BAKERSFIELD CITY SCHOOL DISTRICT
FRANKLIN ELEMENTARY SCHOOL MODERNIZATION
BAKERSFIELD, KERN COUNTY, CALIFORNIA

Job No. 1316
Appl. No. 15-6
File No. 03-122910

ADDENDUM NO. #02
NOTICE TO CONTRACTORS FIGURING THIS WORK

803 BOYS
BLDG 'H'

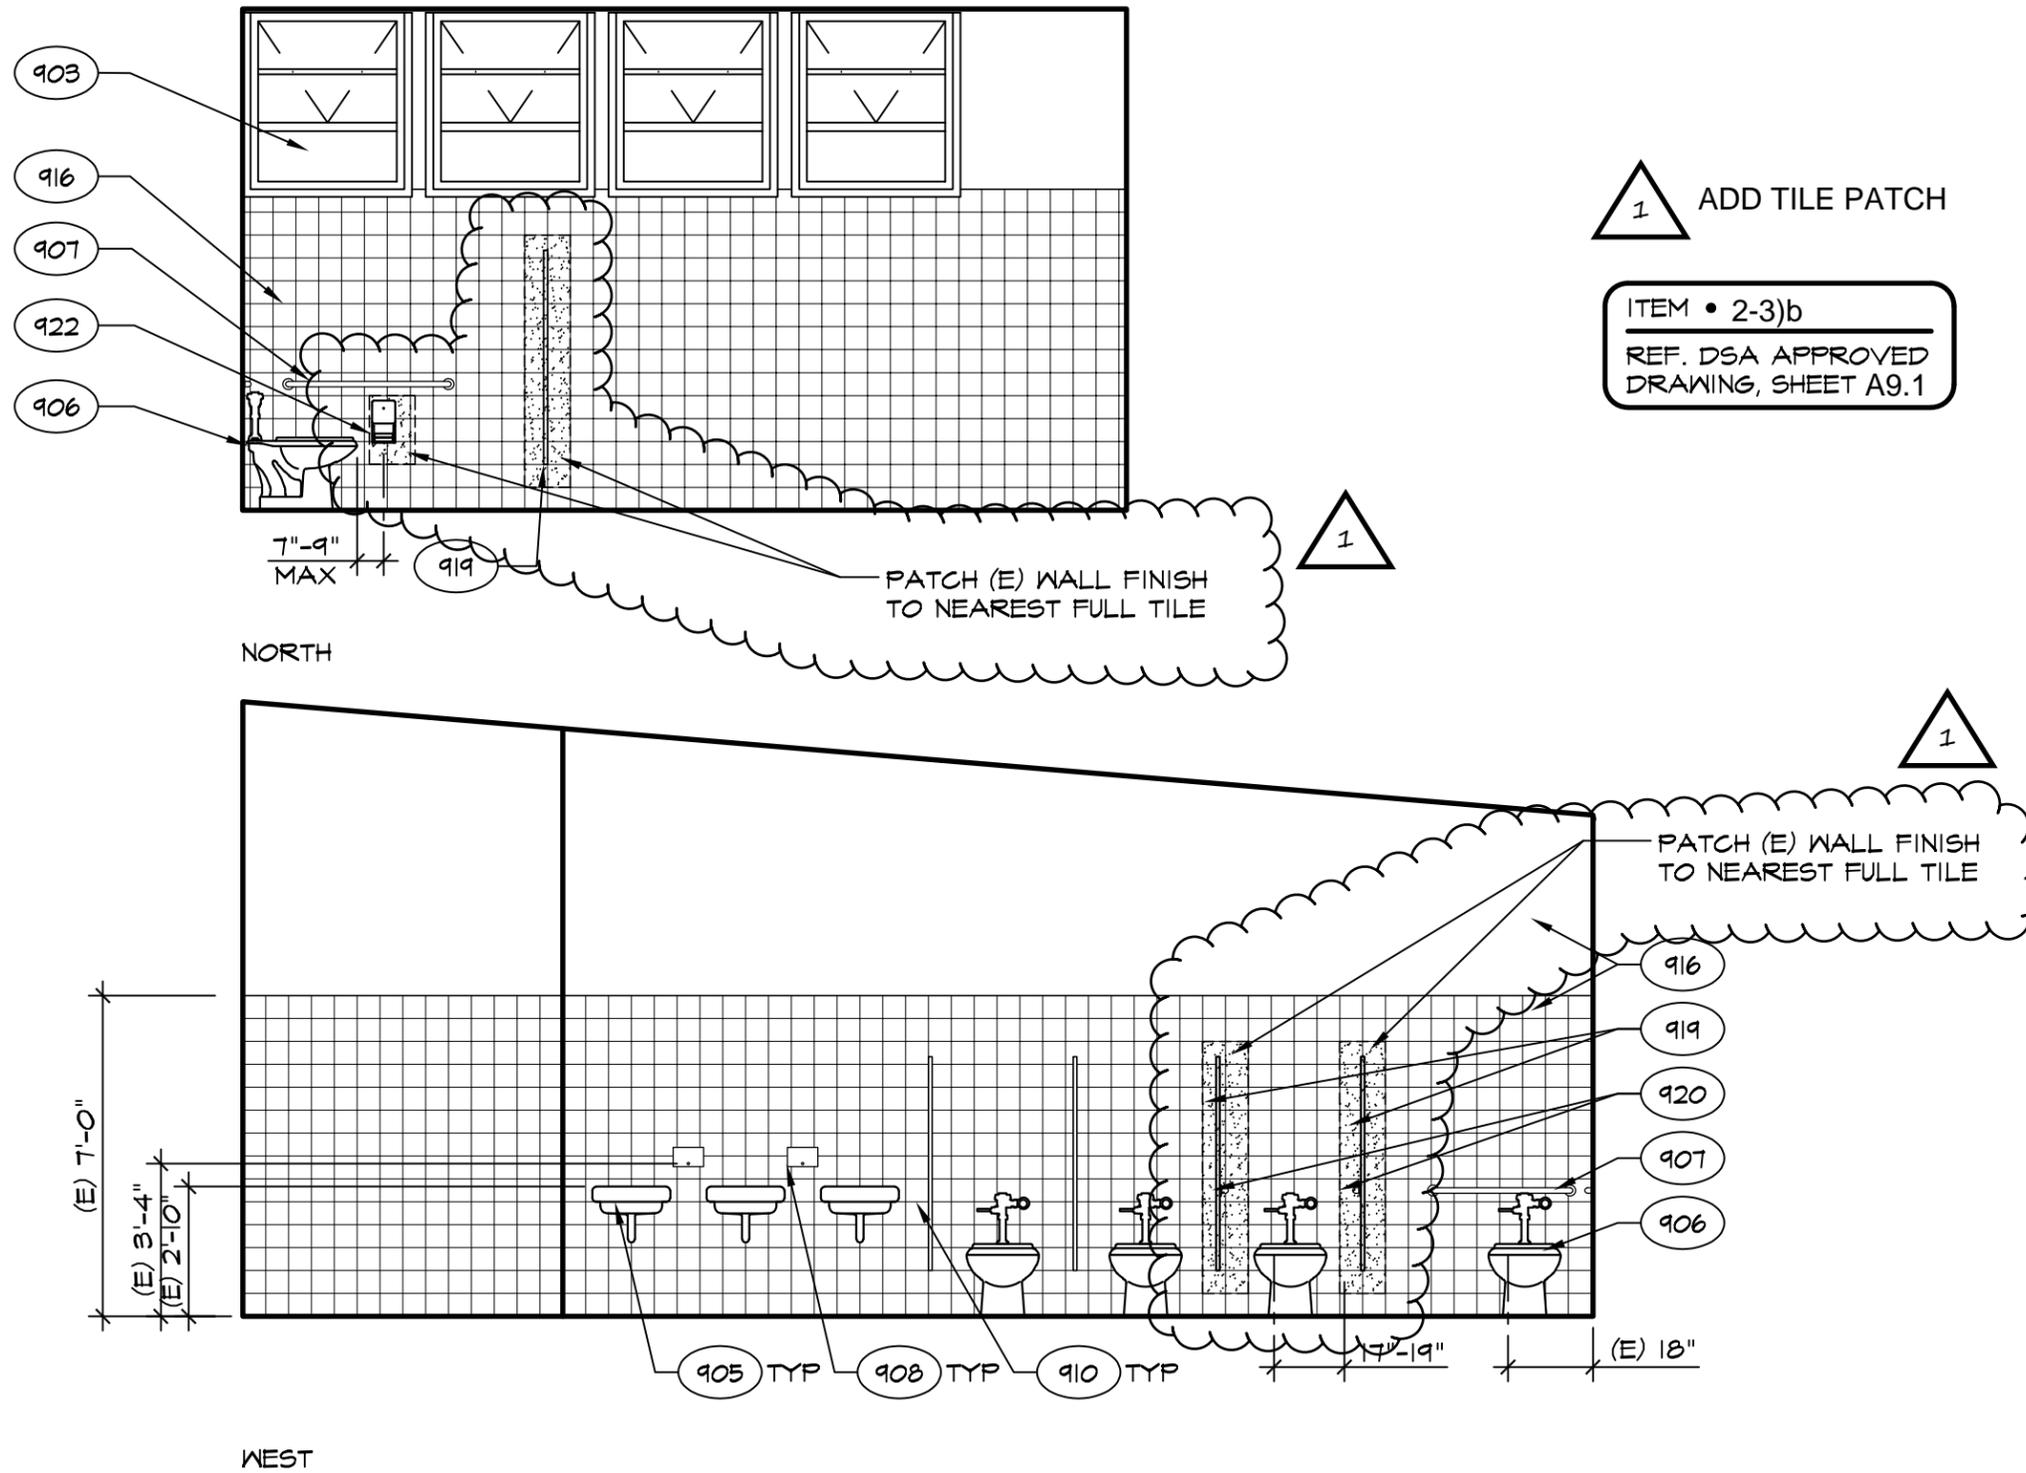
- b. ADD: At 803 Boys North & West, patch and match (E) ceramic tile for the installation of toilet partitions as indicated per attached Drawing No. 06.

GROUNDING DETAIL - PNLS 'A', 'B', 'C', 'D', 'G' and 'L'

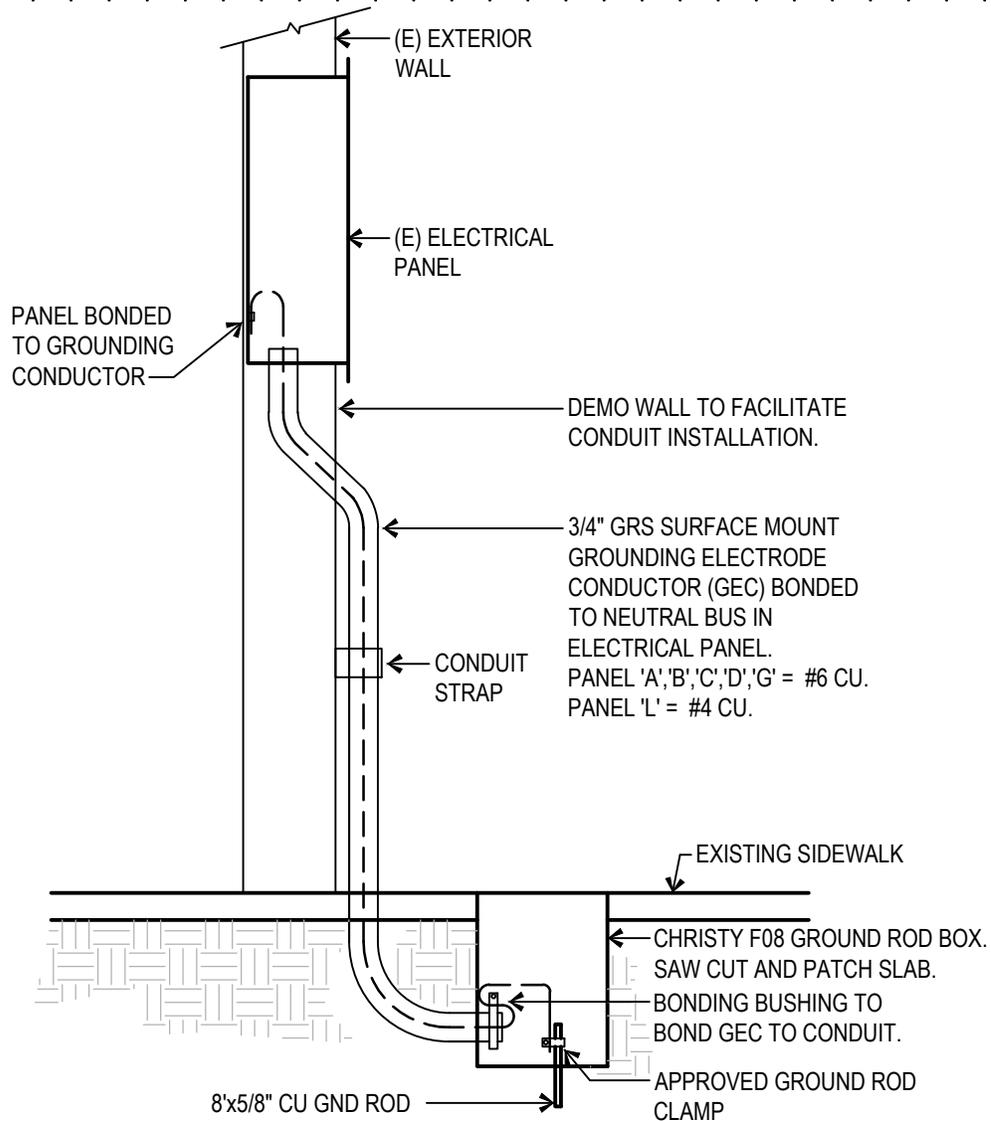
- 2-6) Refer to DSA Approved Drawings, Sheet No. E1.00 ELECTRICAL SITE PLAN, SYMBOL LEGEND, DETAILS AND NOTES;
- a. ADD: Provide grounding electrode conductor (GEC) to panels A, B, C, D, G and L per attached Detail AD2E1.

GROUNDING DETAIL - PNLS 'LG', 'LF', 'LH', 'LI' and 'LC'

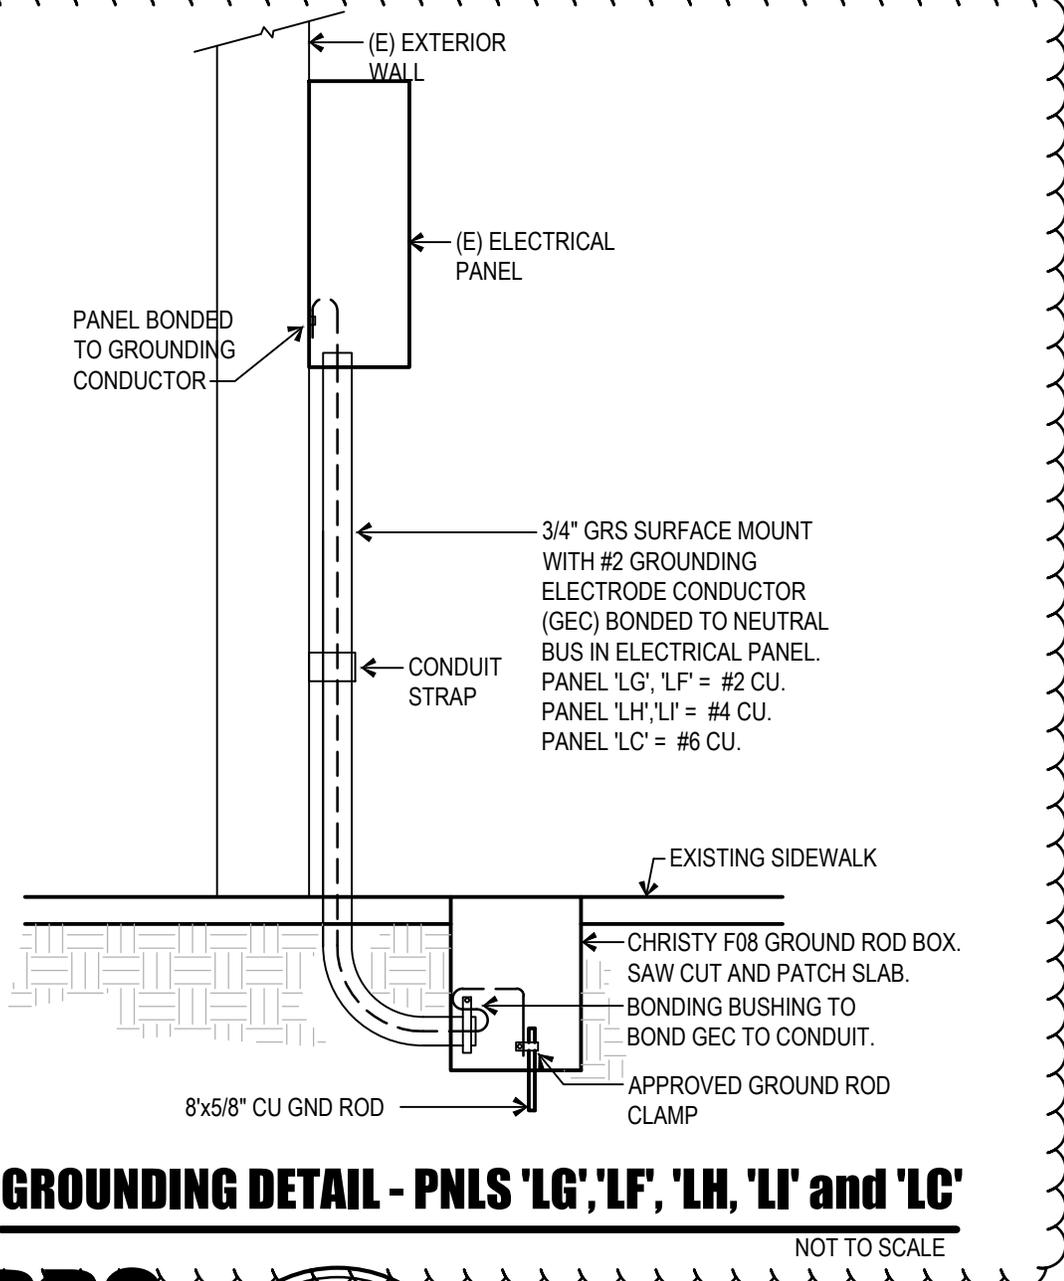
- b. ADD: Provide grounding electrode conductor (GEC) to panels LG, LF, LH, LI, and LC per attached Detail AD2E2.
 - c. ADD: Provide grounding electrode conductor (GEC) to panels LB and LE per attached Detail AD2E3.

ADD PANEL GROUNDING

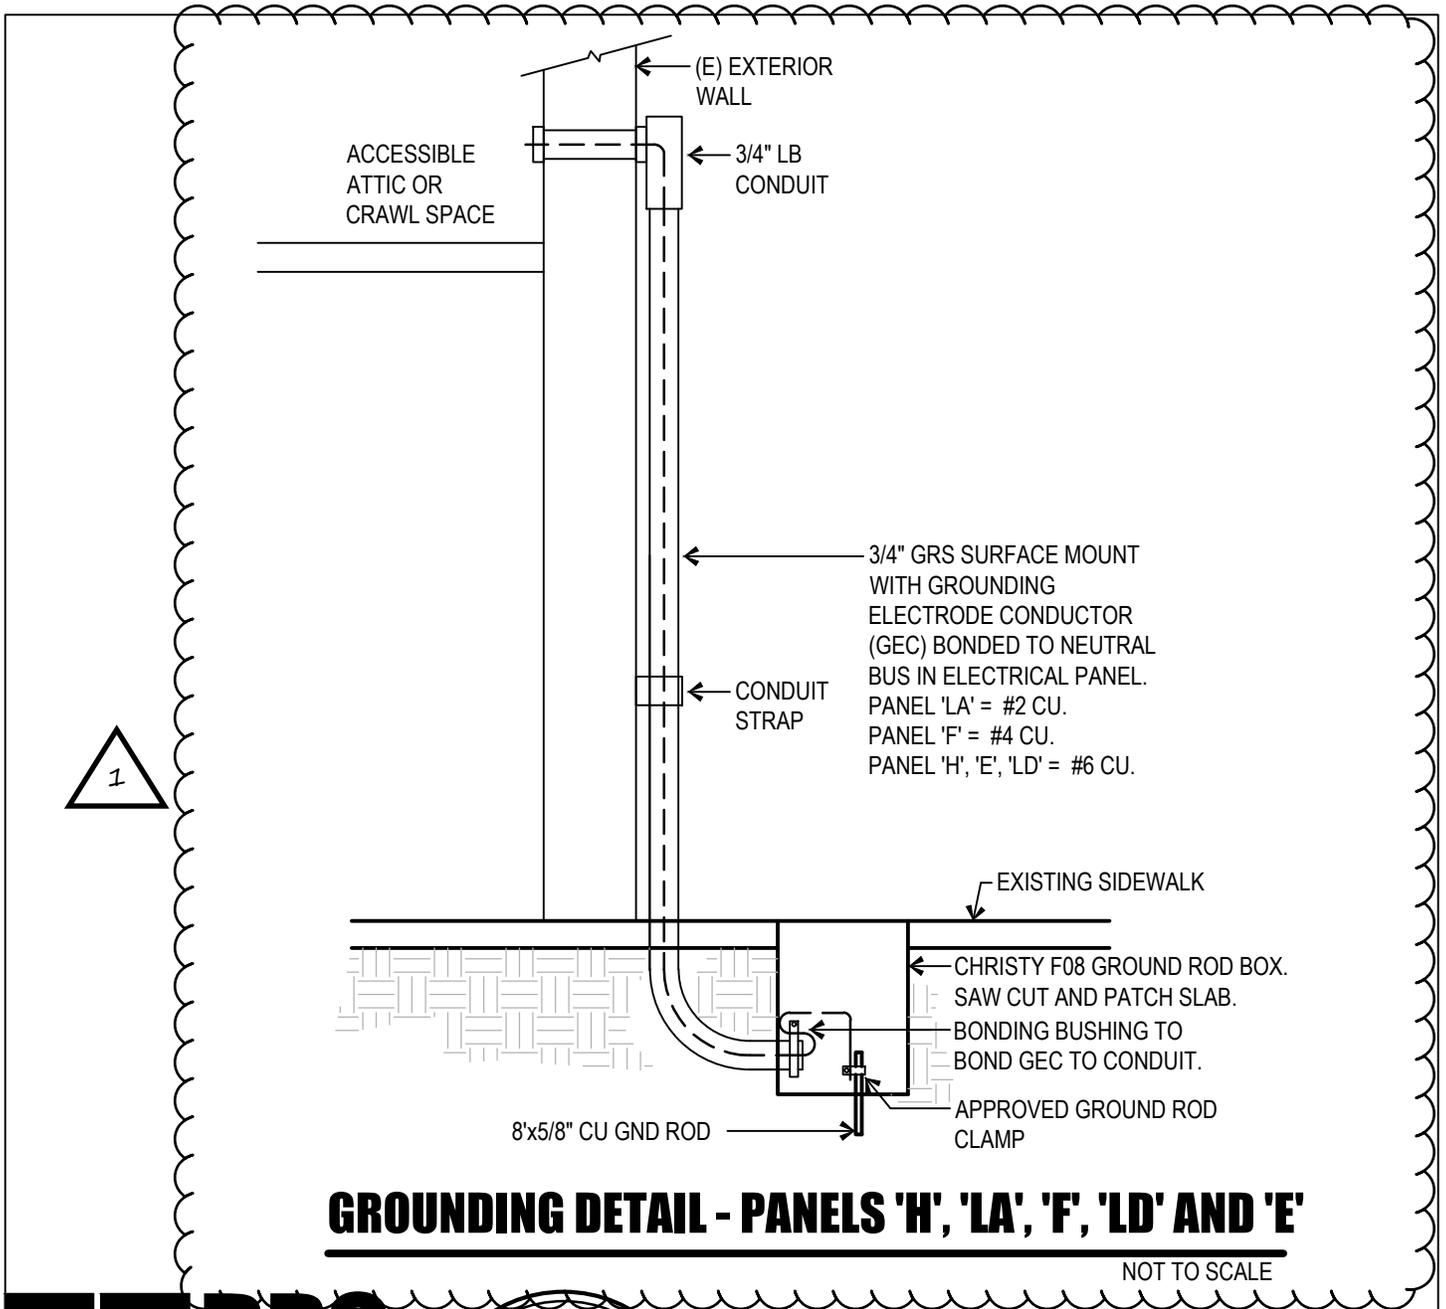
- d. ADD: Provide a ground from the neutral bus of panels LA, H, and F to a ground rod located outside the exterior wall of building A on the west side per attached Detail AD2E4.

- e. ADD: Provide GEC from neutral bus of panels LD and E to a ground rod located on the west side of building D per attached Detail AD2E4.
 - f. REVISE: MSB and PG&E transformer location as indicated per attached Drawing AD2E5.

ELECTRICAL SITE PLAN

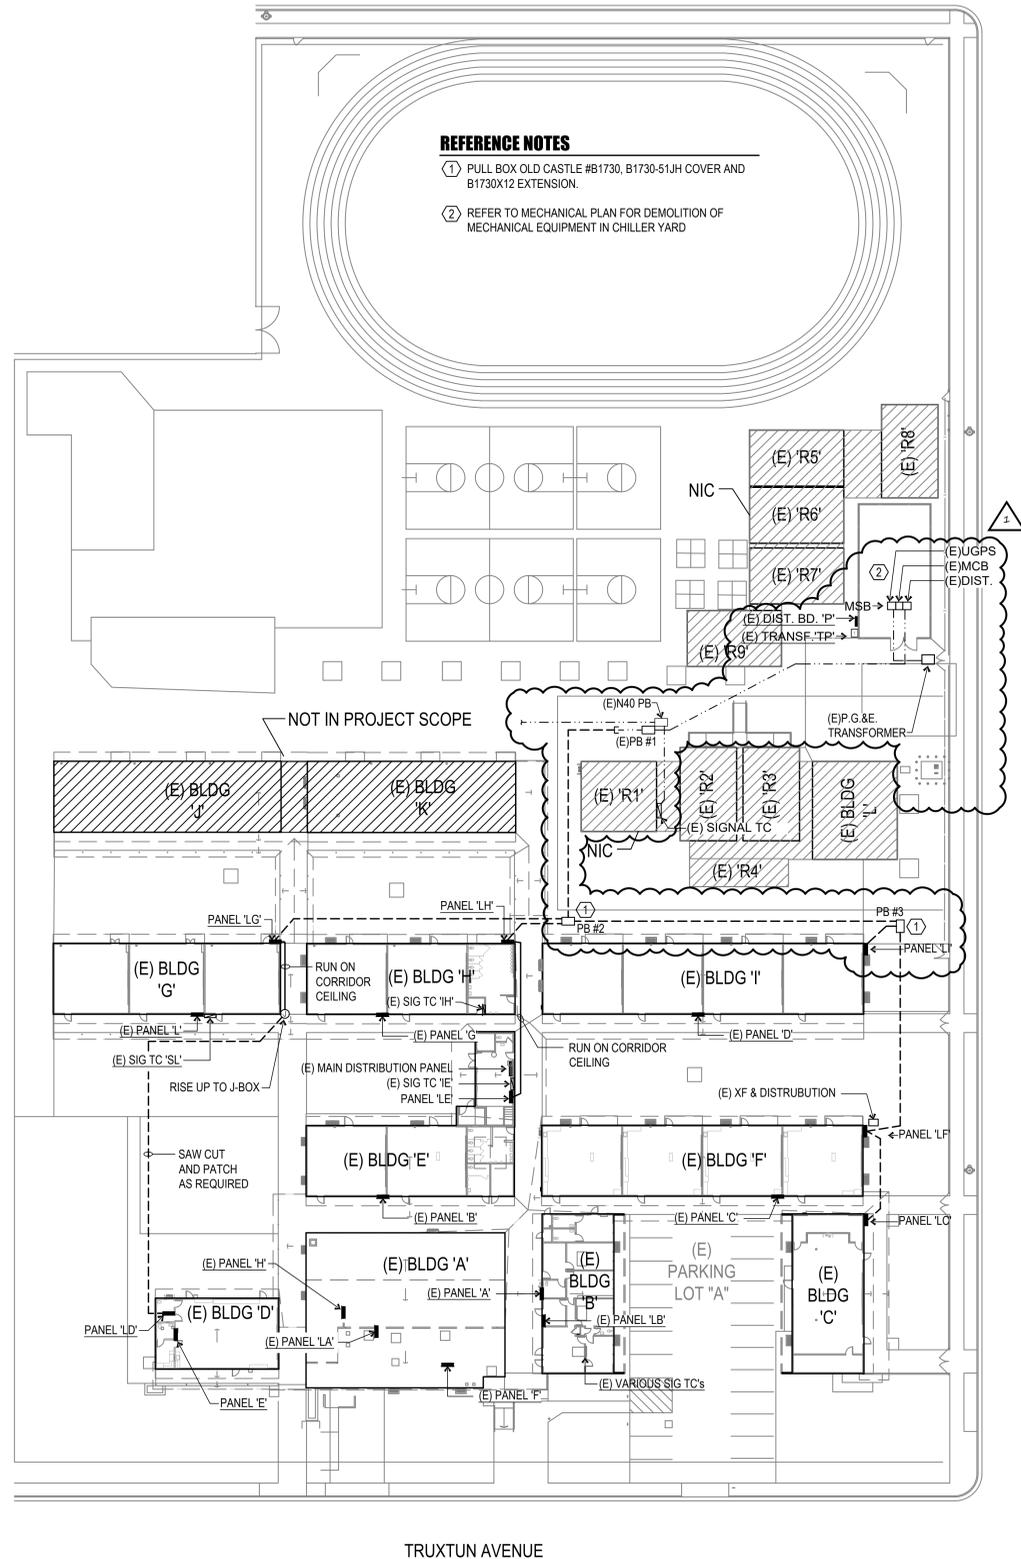
- g. REVISE: Underground conduits from MSB to PB#1 indicated as existing as indicated per attached Drawing AD2E5.
 - h. ADD: Reference Note 1 to PB#2 and PB#3 as indicated per attached Drawing AD2E5
